Connecticut Green Bank

Request for Proposals for Solar Projects at State of Connecticut Facilities – Round 3

RFP Q&A Responses

October 06, 2022

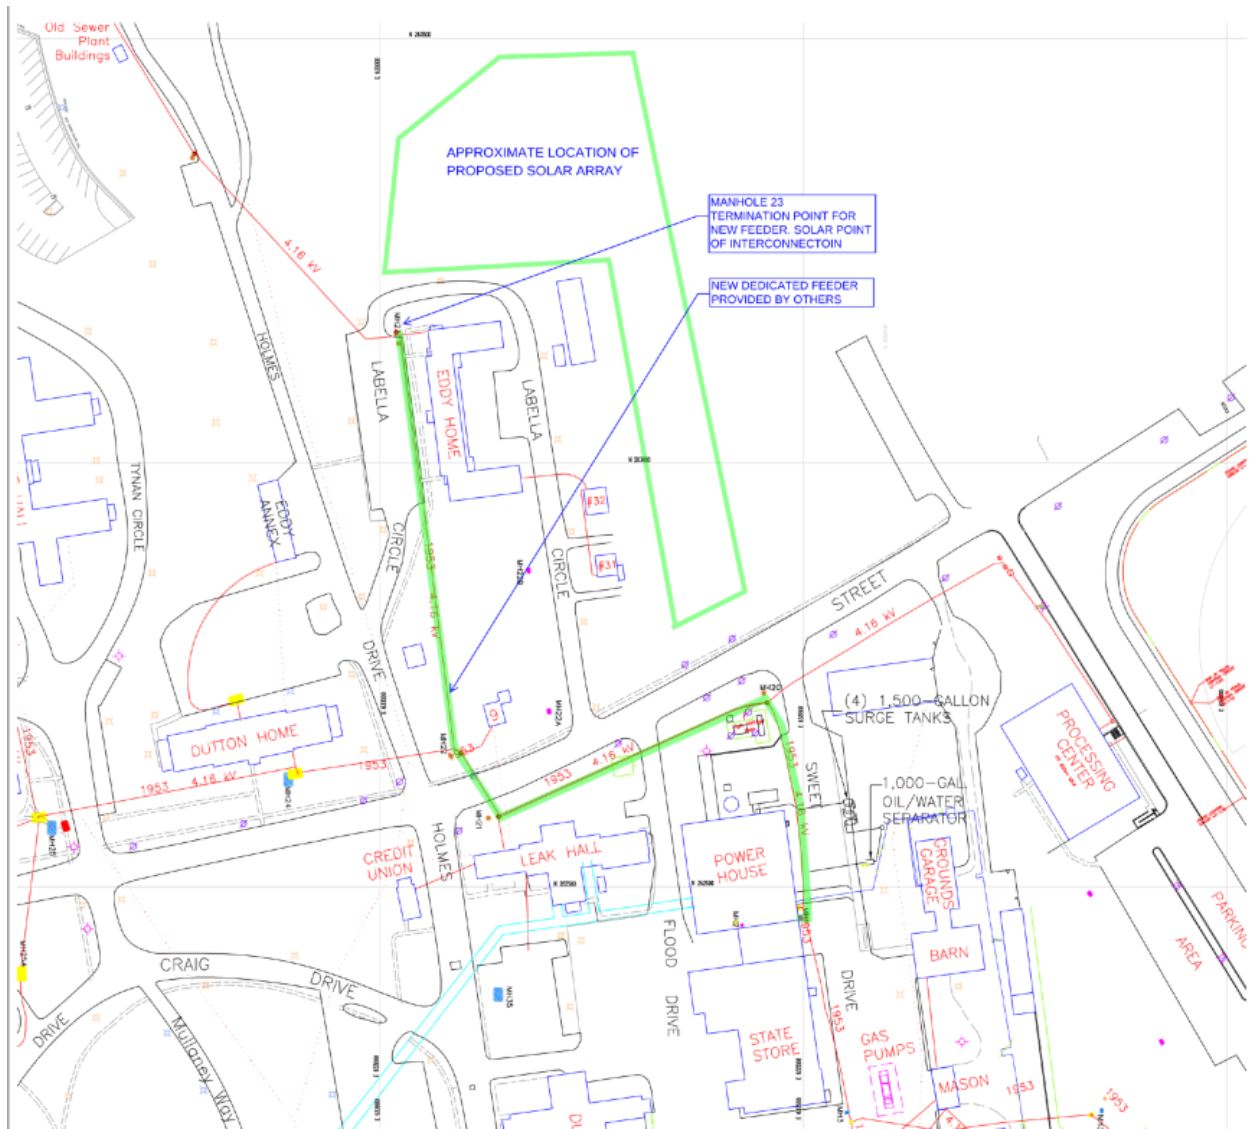
- 1. While at the site visit for the Connecticut Valley Hospital last Thursday, several questions were raised about the interconnection point for the equipment. We were told at the time that they would investigate more options and let us know. Since the due date is fast approaching is it possible to get an update on this?**

In lieu of interconnecting to the existing 4160V circuit conductor at Eddy Hall a new dedicated feeder will be provided by others. This new 4160V feeder will run in the existing underground tunnel from the site's Power House and terminate at Eddy Hall, specifically in Manhole 23 (MH@#) on the MAP provided below. This is directly adjacent to the transformer vault at Eddy Hall observed during the site visit.

Proposers will be responsible for connecting to this feeder at MH23, providing a transformer and electrical switchgear necessary for interconnection of the Project. Therefore, the scope remains unchanged, and Proposers can expect to have a new dedicated feeder provided by others for interconnection.
